LaSalle County Station, Units 1 and 2
Facility Operating License Nos. NPF-11 and NPF-18
NRC Docket Nos. 50-373 and 50-374

Subject: Application for Amendment to Appendix A, Technical Specifications, Section 3/4.4.6, "Pressure/Temperature Limits, Reactor Coolant System," and Request for Exemption from 10 CFR 50.60, "Acceptance Criteria for Fracture Prevention Measures for Lightwater Nuclear Power Reactors for Normal Operation"

ATTACHMENT A
Proposed Technical Specification Changes for
LaSalle County Station, Units 1 and 2
Page 1 of 8

DESCRIPTION AND SAFETY ANALYSIS
FOR PROPOSED TECHNICAL SPECIFICATION CHANGES

Figure 3.4.6.1-1

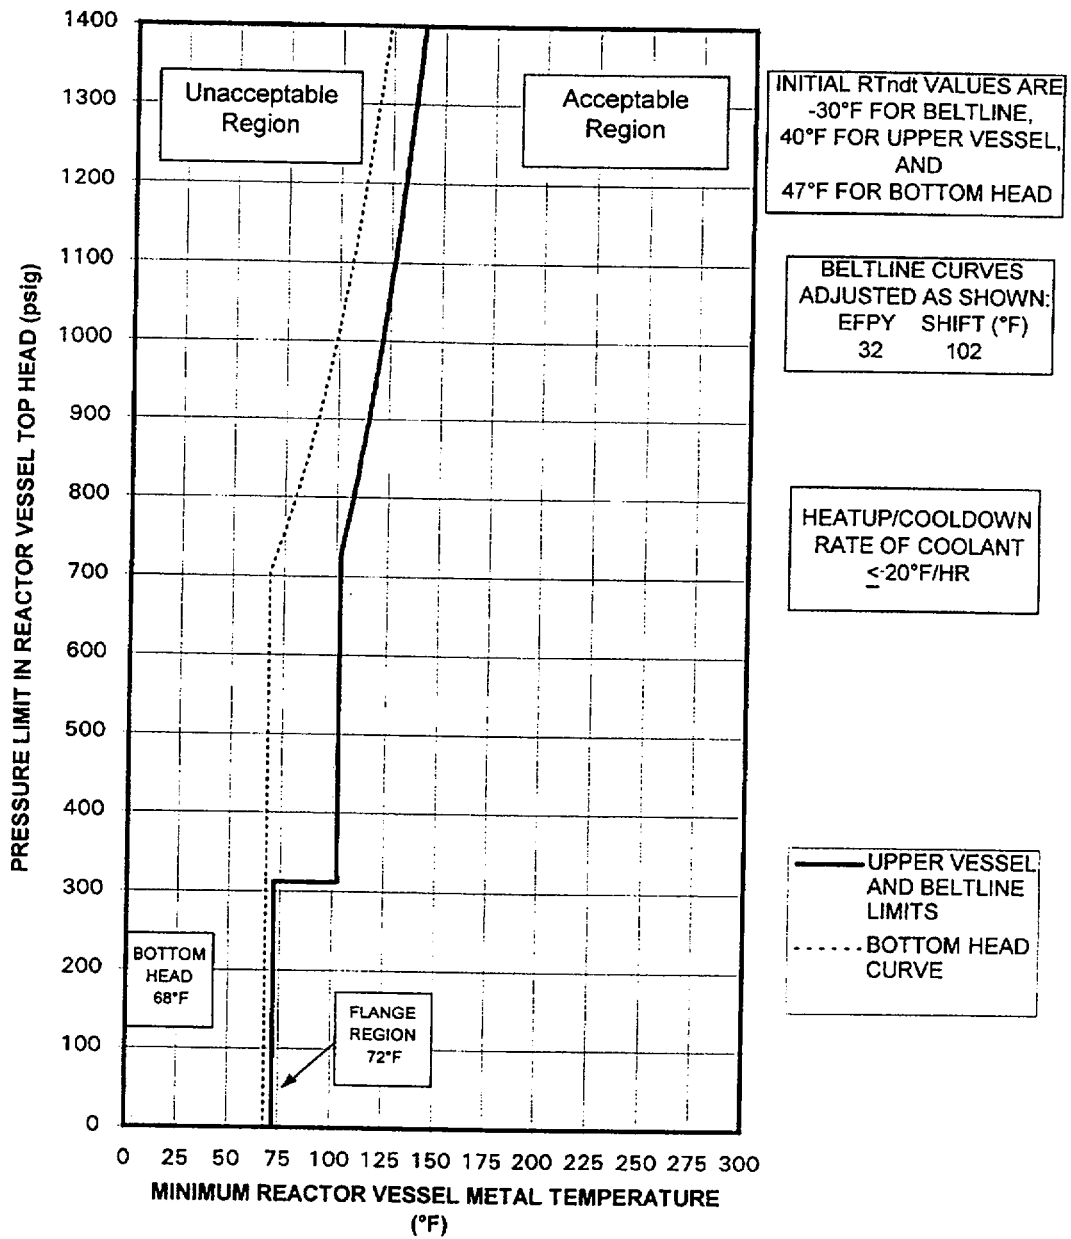
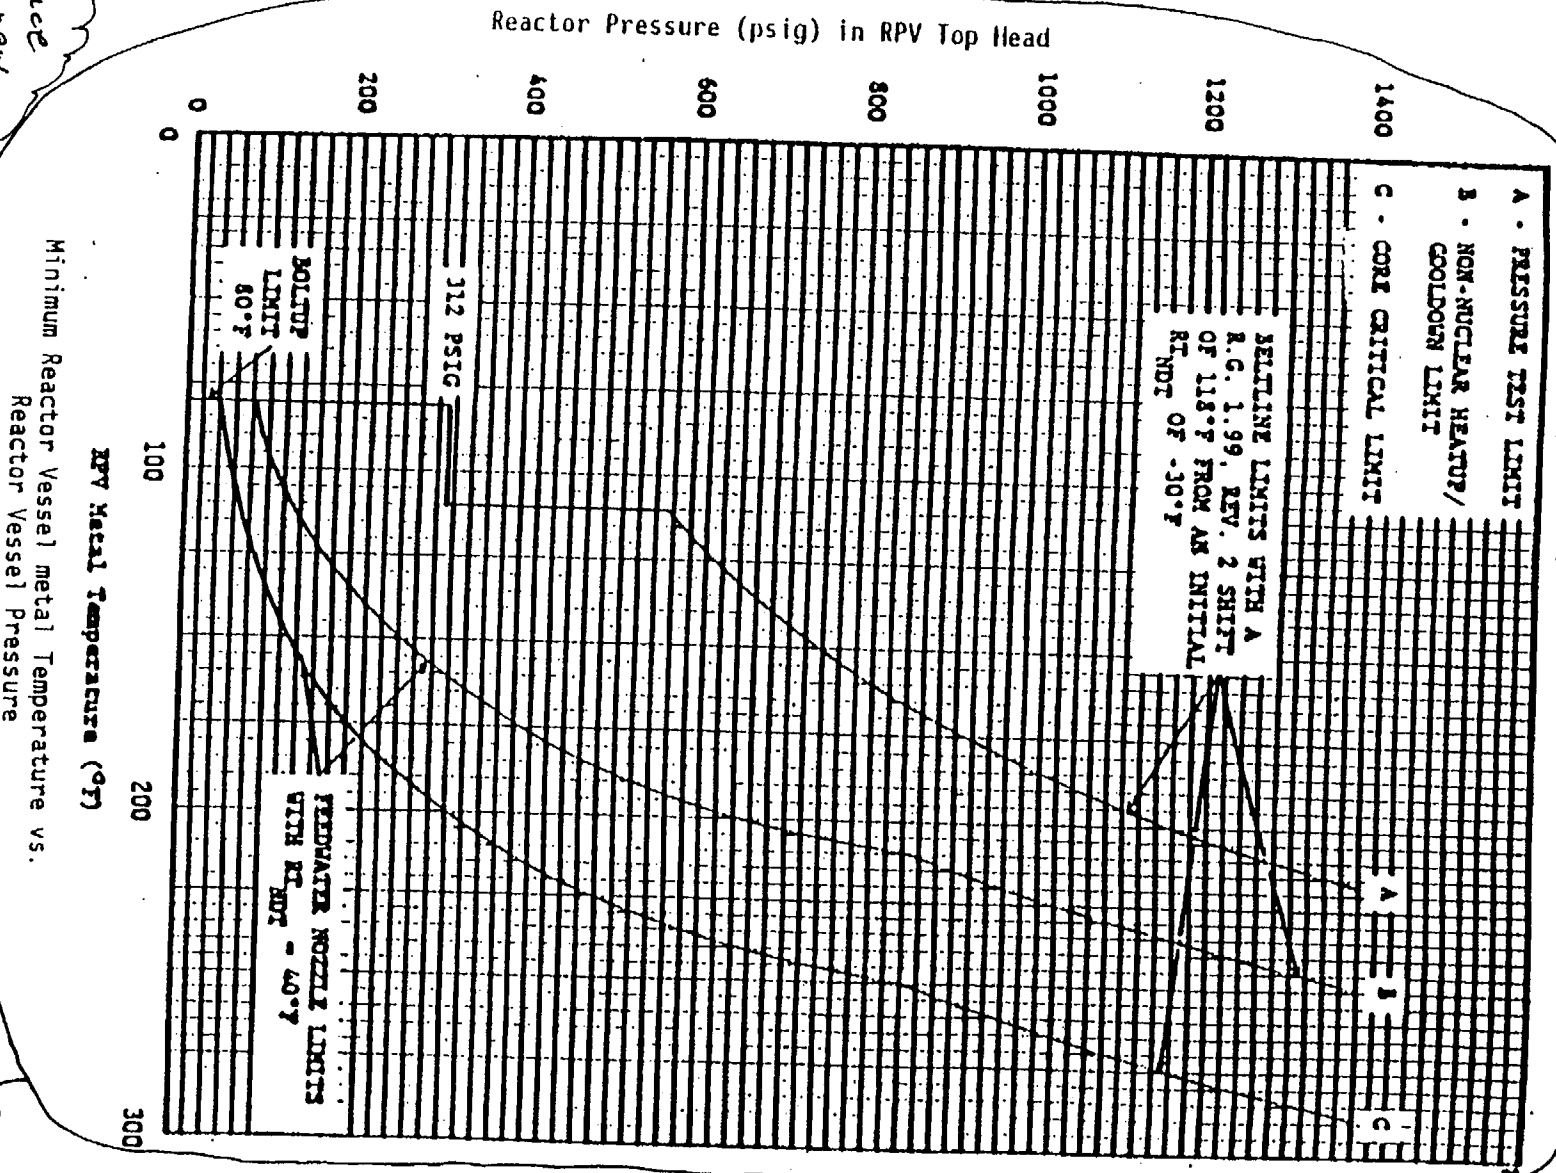
The proposed changes to TS Figures 3.4.6.1-1 and 3.4.6.1-1a are to replace the current 16 and 32 EFPY curves with three recalculated 32 EFPY curves and to change the associated descriptions contained on each page.

Replace with new Figure 3.4.6.1-1

P-T Curve for Hydrostatic or Leak Testing

Figure 3.4.6.1-1a

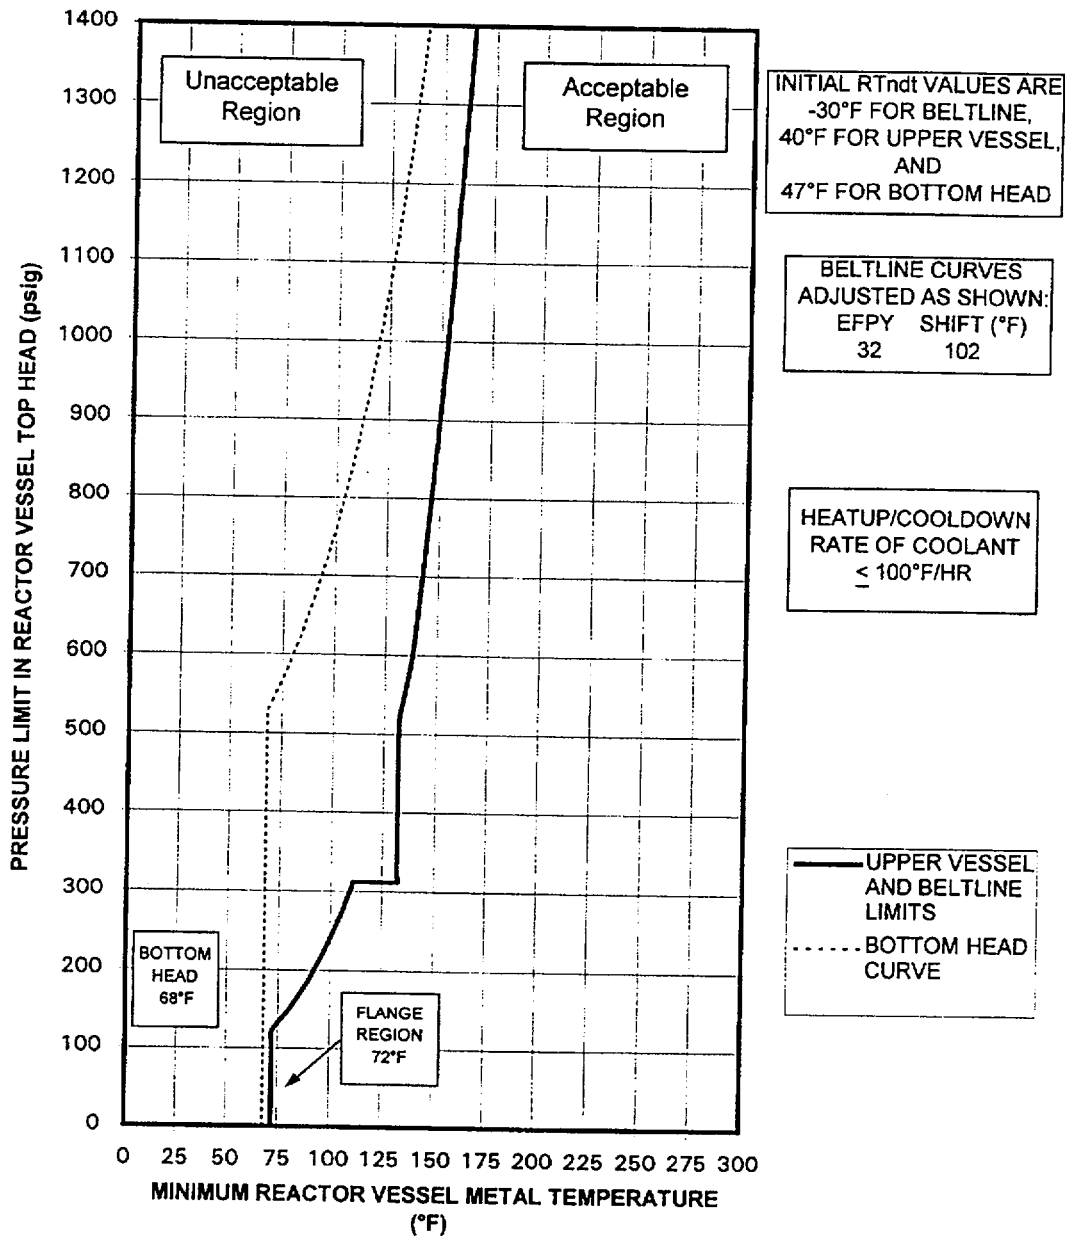
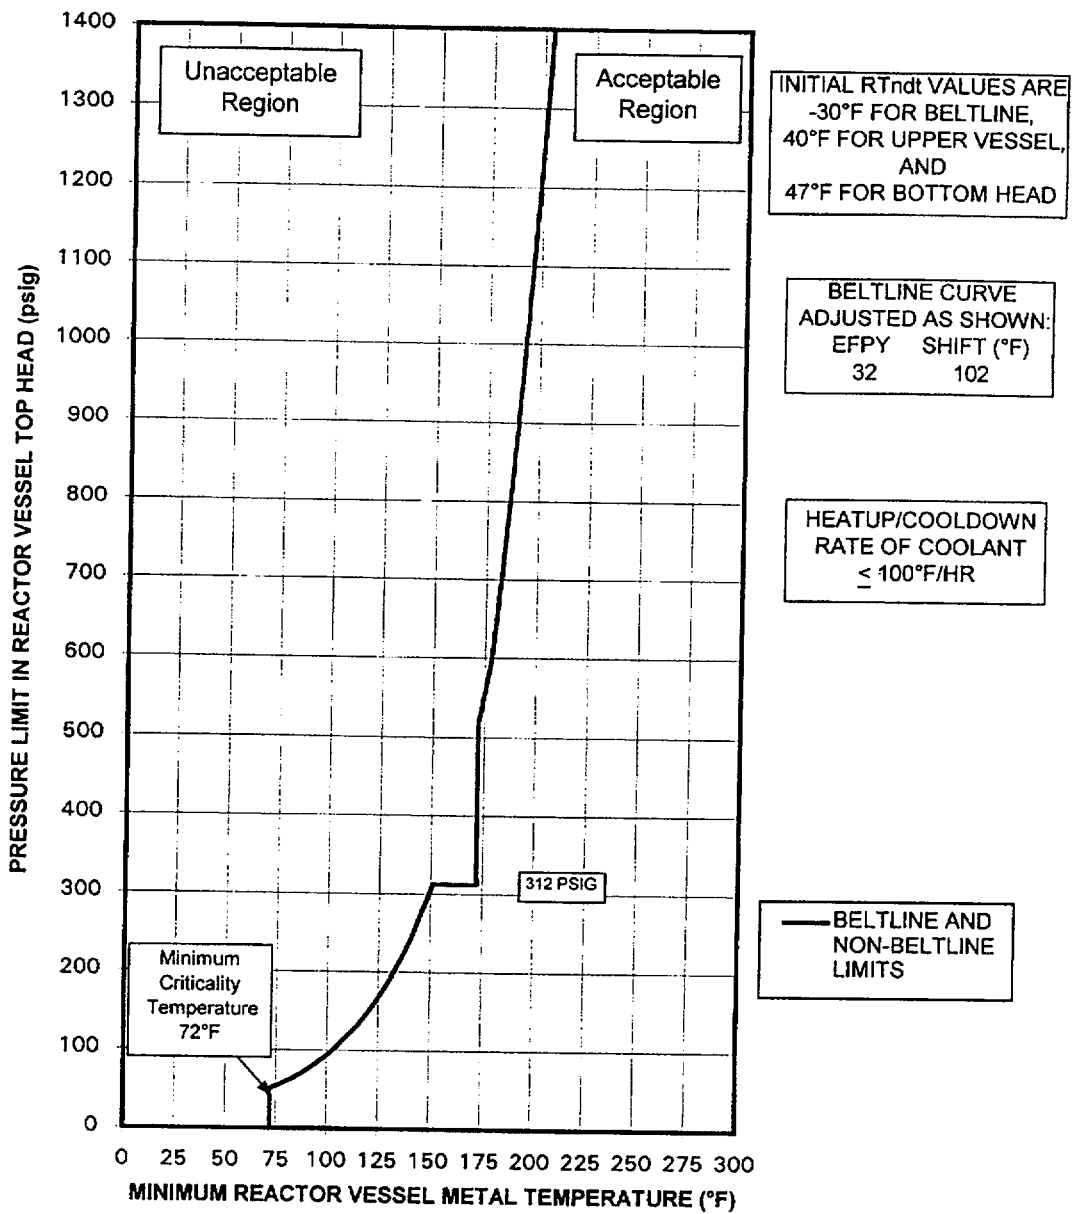
Replace
with new
Figure 3.4.6.1-1a

P-T Curve for Heatup by Non-Nuclear Means,
 Cooldown Following a Nuclear Shutdown and Low Power PHYSICS TESTS

Figure 3.4.6.1-1

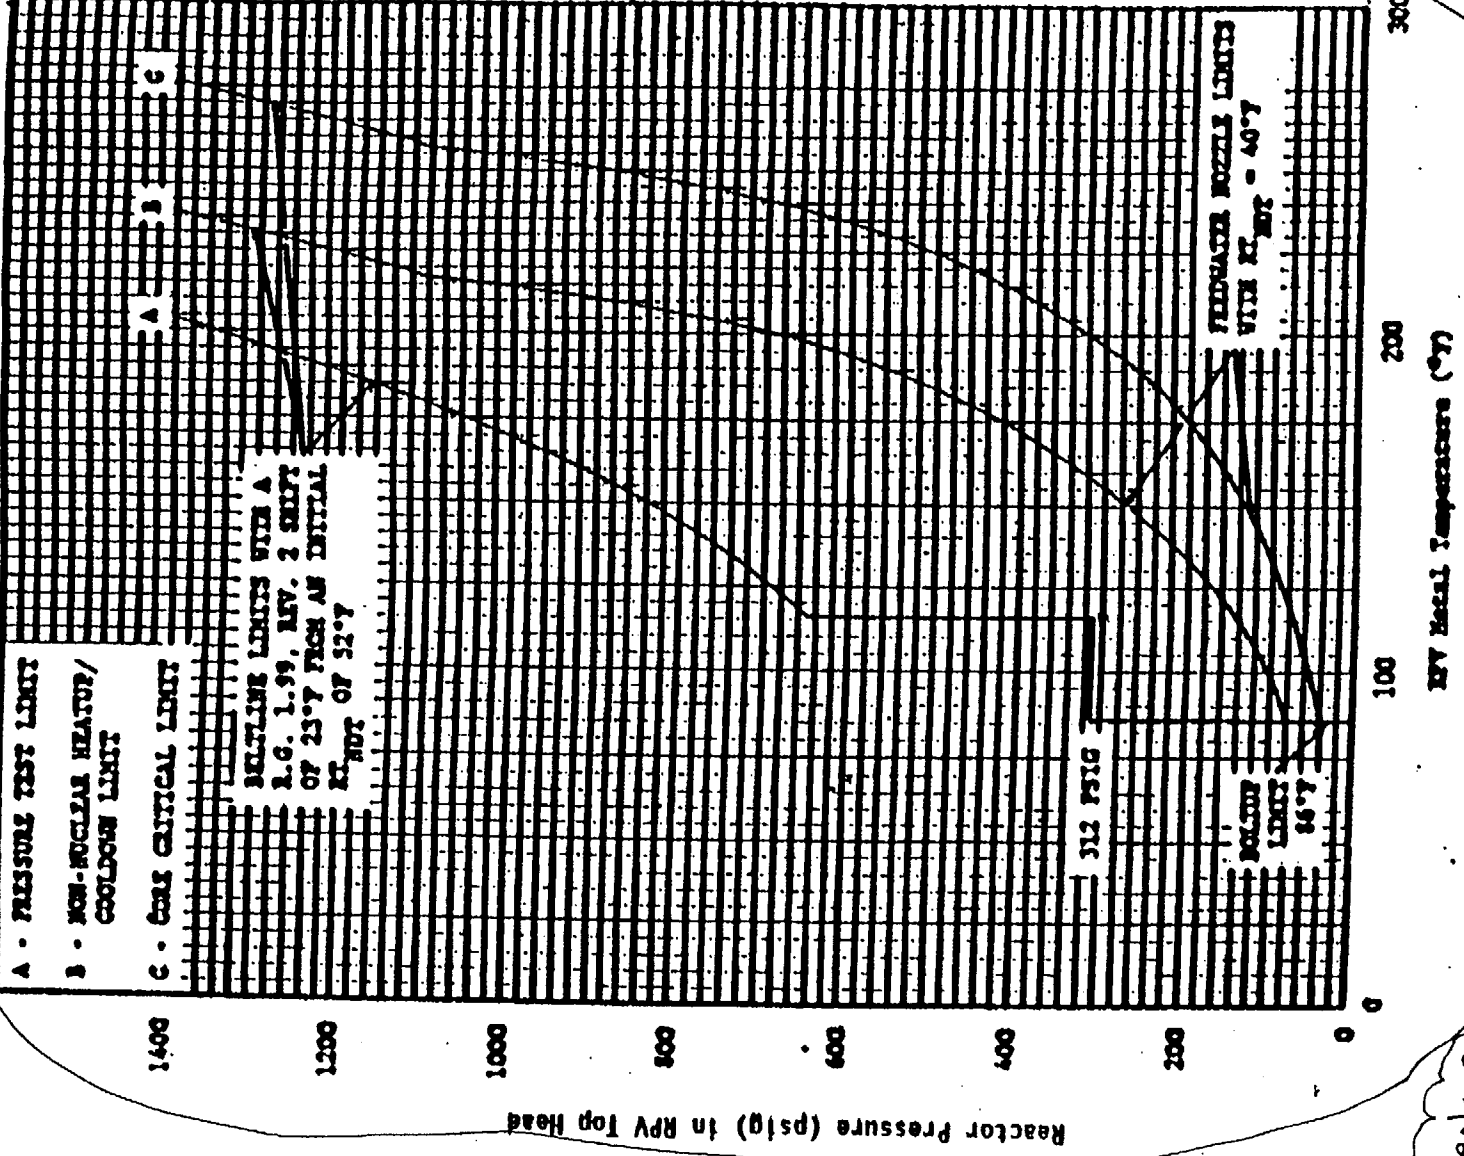
The proposed changes to TS Figures 3.4.6.1-1 and 3.4.6.1-1a are to replace the current 16 and 32 EFPY curves with three recalculated 32 EFPY curves and to change the associated descriptions contained on each page.

Figure 3.4.6.1-1a

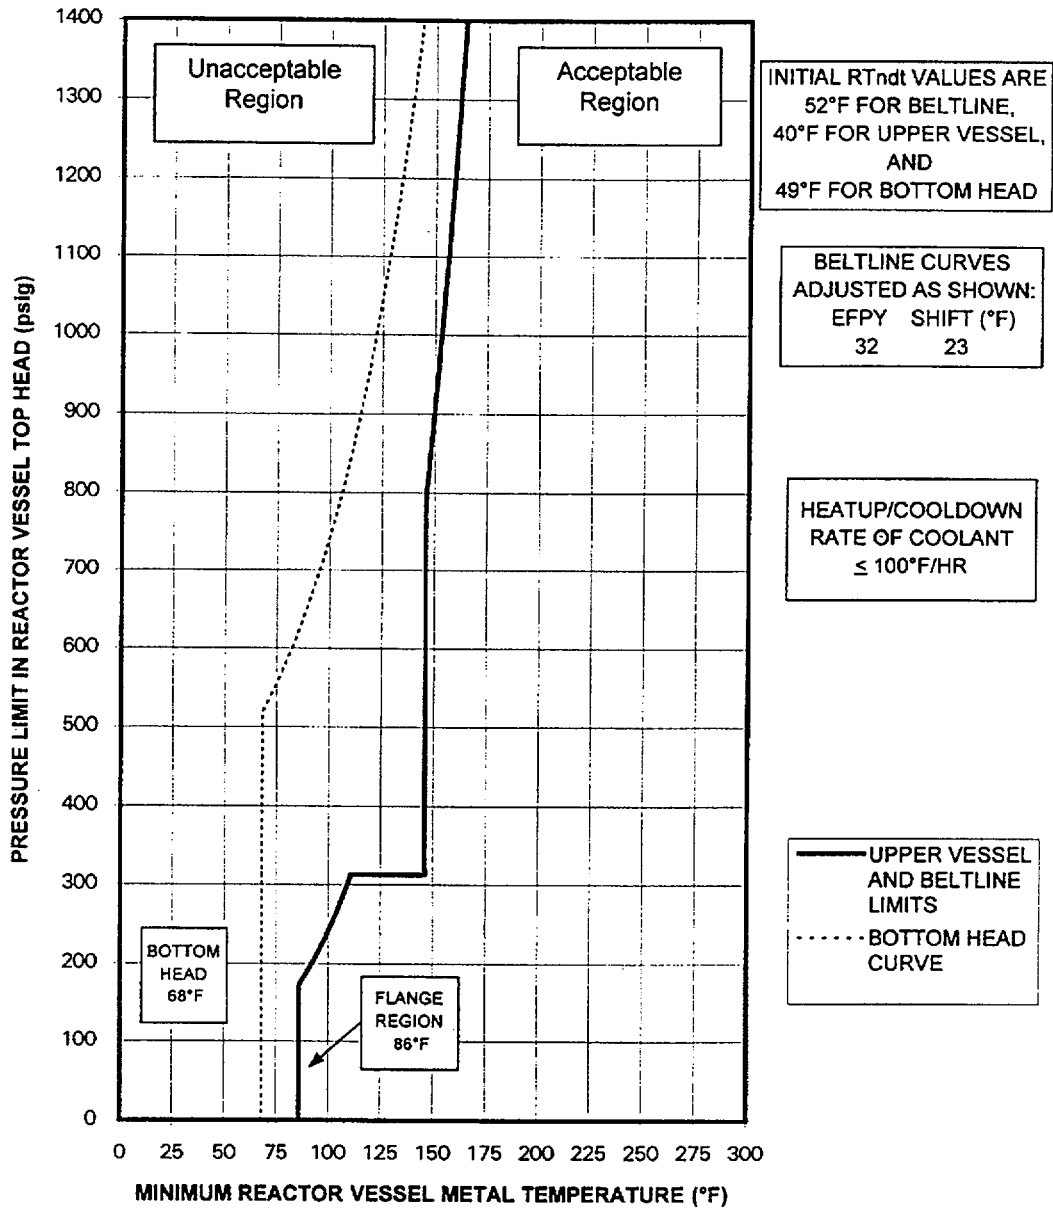
Replace with new Figure 3.4.6.1-1a

P-T Curve for Heatup by Non-Nuclear Means,
 Cooldown Following a Nuclear Shutdown and Low Power PHYSICS TESTS

Figure 3.4.6.1-1b

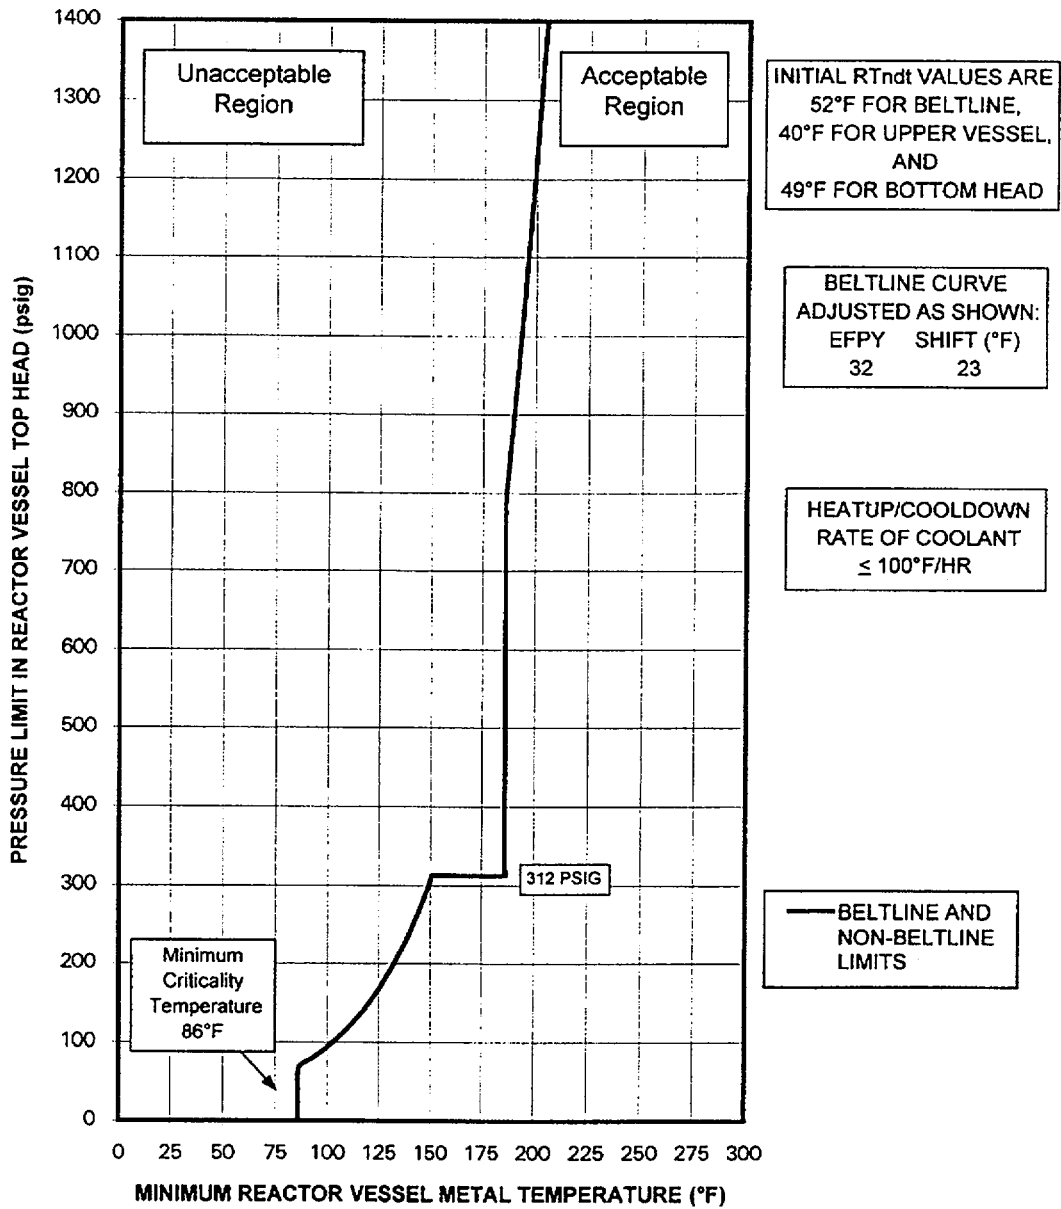
The proposed change to TS Surveillance 4.4.6.1.1 is to remove the reference to Curves A and B, and to include the reference to TS Figure 3.4.6.1-1b.

Replace with
new Figure 3.4.6.1-1b

P-T Curve for Operation with a Critical Core other than low power PHYSICS TESTS
